National Signal Maintenance Standards Briefing June 2025

Standards covered by this briefing

- **NR/L3/SIG/10663 Signal Maintenance Specifications (SMS)**
- **NR/L3/SIG/10064 General Instructions for Staff working on S&T Equipment (GI's)**
- **NR/L3/SIG/11231 Signal Maintenance Testing Handbook (SMTH)**

SMS PART B – TEST 041 - Insulated Rail Joint (IRJ) Tests

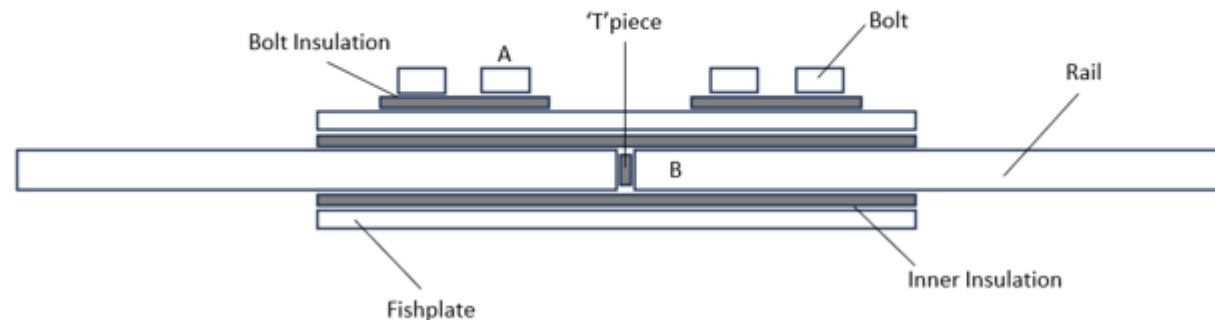
Clarified testing steps

Separated clause 4, to check the resistance between each rail across the "T" piece is at least 150 Ohms.

Clarity added to 4.10 for where a site fitted IBJ is installed, a picture shows how to test resistance of the bolt to opposite rail.

NOTE: Where a site fitted (not pre-fabricated) IBJ is installed, instead check the resistance between each fishplate bolt and the opposite polarity rail as depicted A-B in the below diagram. This shall be at least 150ohms.

SMTH - PART 01 - MODULE 12 – The Diversion of a Circuit/Relay Contact or Emergency Equipment Relocation

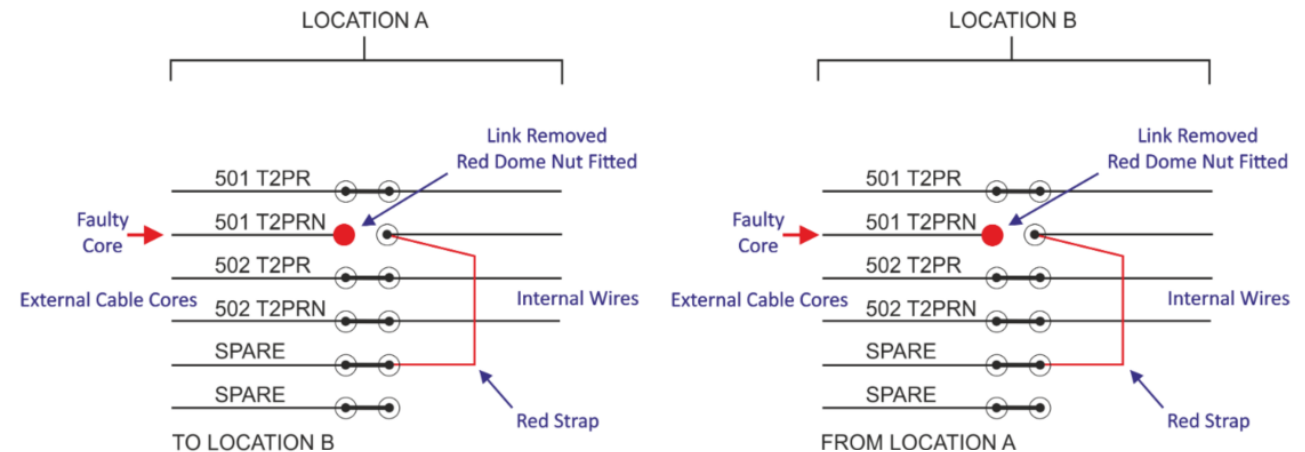
- The document has been reformatted. This was to provide a dedicated section for each termination type. The intention was to make the document easier to follow for the end user.
- A minor update in the 'Guidance for all diversions' requiring the technician to provide a picture of the diversion and diagrams to the SM(S) as soon as possible following the diversion.
- References now to CA05 to bring the new cable maintenance testing standards in alignment.
- The following symbols have been included in the module to allow for example schematics to be provided throughout the document.

SMTH - PART 01 - MODULE 12 –

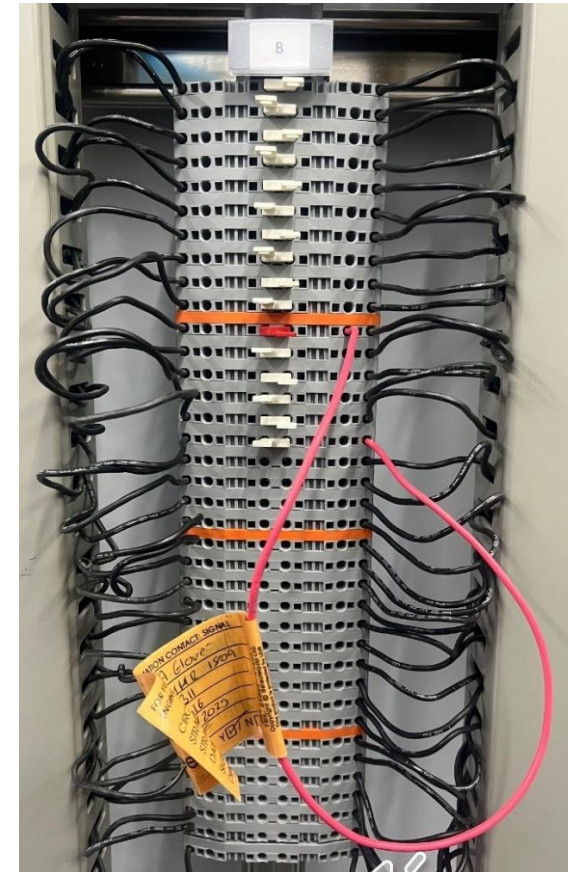
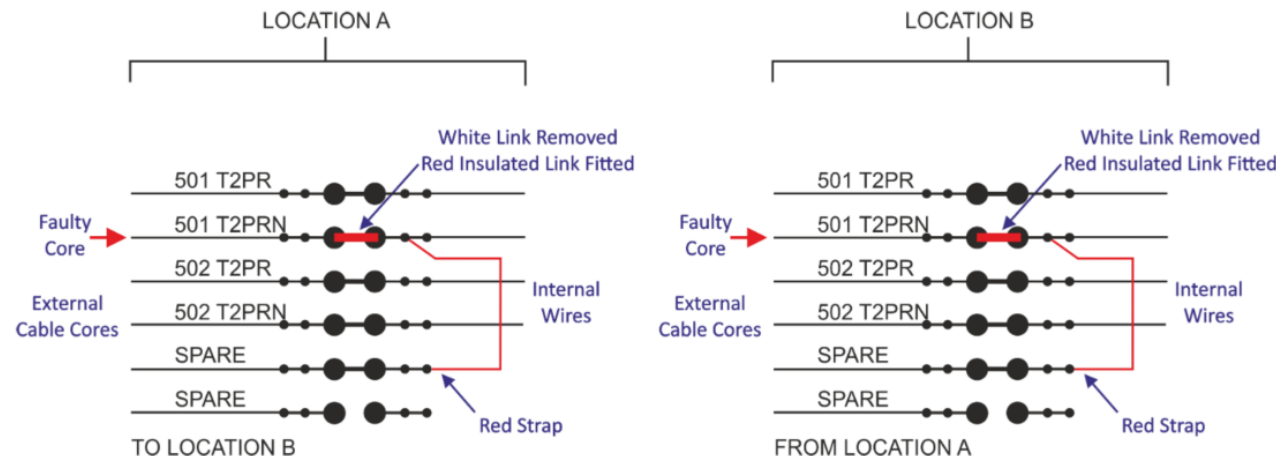
- Diversion of a faulty cable core using sliding links includes an example schematic and picture to provide improved guidance to the technician.
- An updated cable core temporary label has been added to the document to reflect current practice.

SMTH - PART 01 - MODULE 12 – The Diversion of a Circuit/Relay Contact or Emergency Equipment Relocation

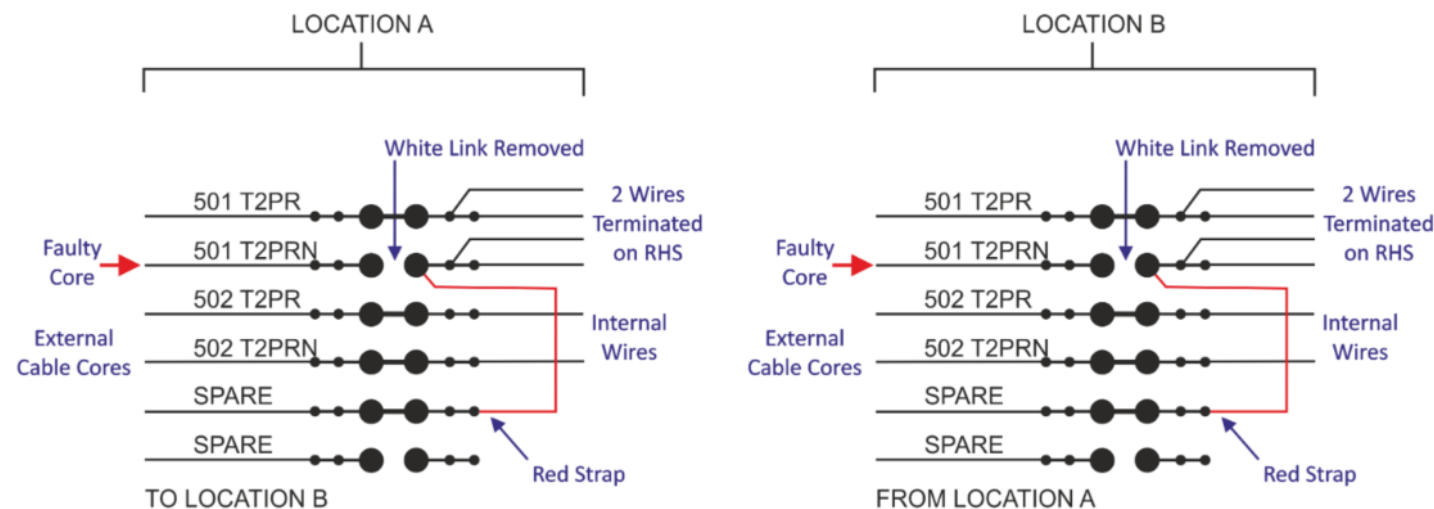
- Guidance on diversions on Wago terminals now included (previously missing).
- Diversion on Wago terminals has been given two methods (referred to in the document as Method 1 and Method 2).
- Method 1 is where a red strap is to be terminated in the spare terminal (as per schematic and picture). In this instance a red insulation link is used.

- Method 2 is utilised when a spare terminal is not available. For example, where two wires are terminated and the link terminal is to be used to implement the diversion.
- This is shown in the schematic and picture.
- In this instance, the red wire is acting as the red insulated link.
